RE: Lock Avenue Apartments (DR17-078)

WALKSacramento has reviewed the project routing for Lock Avenue Apartments and we offer the following comments. Since the project was routed in March and we are just now responding, our comments are in an abbreviated form to hasten the submission.

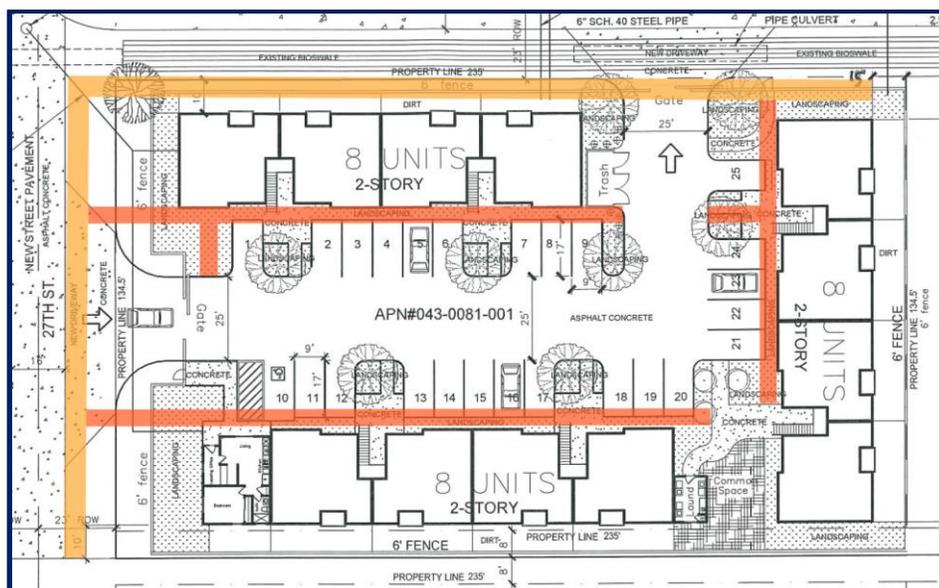
- There should be sidewalks on the edge of right-of-way along Lock Ave and 27th Street.
- Each building should have a sidewalk connecting directly to the street sidewalk.
- Pedestrian gates should be located away from the driveways.
- The entryways and stairwells for each building should be connected by a sidewalk.
- Sidewalks in front of each building should be extended to each other via a combination of sidewalks and drive aisle crossings.

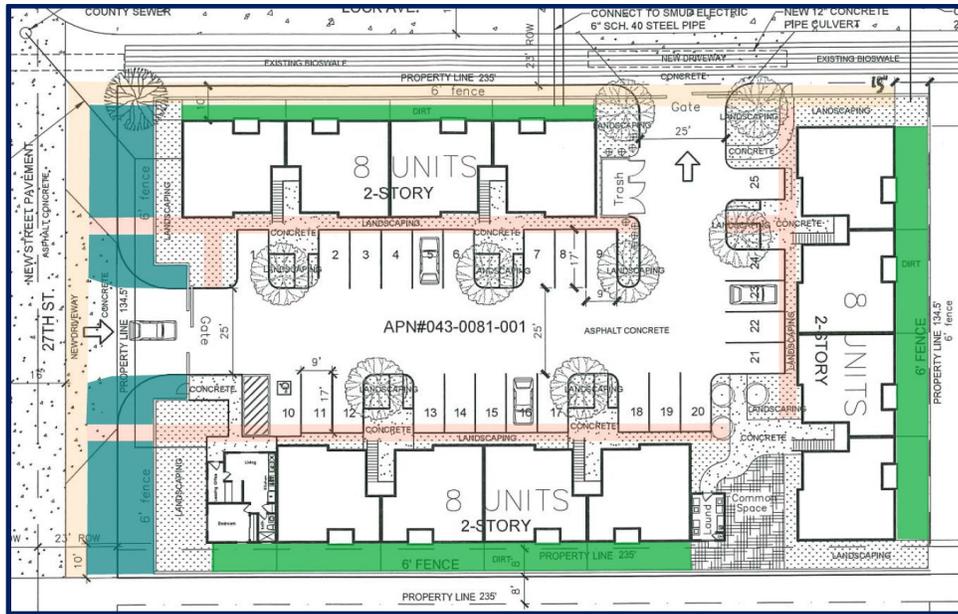
- First floor terraces should open to landscaping.
- Street trees should be provided.
